Humayun's Tomb (India)

No 232 Bis

Humayun's Tomb, Delhi

2 Issues raised

Map showing the revised boundaries of the property and the buffer zone

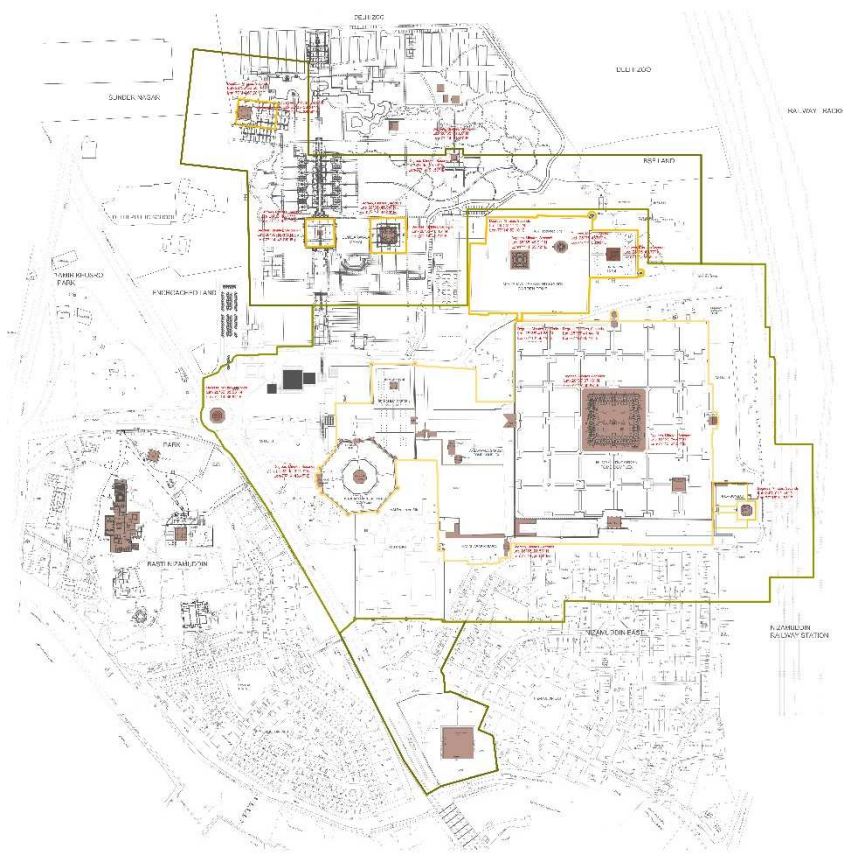
The State Party proposes to add an additional area of 5.44 ha to the property boundary, and an additional area of 53.21 ha to the buffer zone.

The areas proposed to be added to the property boundary comprise six distinct zones: Mirza Muzaffar Hussain's Garden Tomb (3.34 ha); an unknown Mughal garden tomb (0.82 ha); Sunderwala Mahal Garden Tomb (0.37 ha); Sundar Burj Garden Tomb (0.23 ha); Nila Gumbad's Garden Setting (0.37 ha); and Lakkarwala Burj Garden Tomb (0.31 ha). In the case of Nila Gumbad, the monument and its garden setting were separated by a roadway at the time of inscription, but the Archaeological Survey of India, assisted by the Aga Khan Trust for Culture have worked to restore this linkage, allowing an improvement in the integrity of this component monument.

The proposed modification to extend the buffer zone is based on the proposed revised property boundary. Additional monuments that will be included in the proposed additional areas in the buffer zone include: Sabz Burj (early 16th century tomb); an 18th century Garden Tomb; and the 17th century Abdur Rahim Khan-i-Khanan's Garden Tomb.

ICOMOS considers that the proposed modifications to the property boundary and buffer zone for Humayun's Tomb will contribute to protection of Outstanding Universal Value of the property and will strengthen the management of the World Heritage property and its presentation to visitors.

ICOMOS recommends that the proposed minor modification to the boundary of Humayun's Tomb, Delhi, India, be **approved**.

ICOMOS recommends that the proposed buffer zone for Humayun's Tomb, Delhi, India, be **approved**.
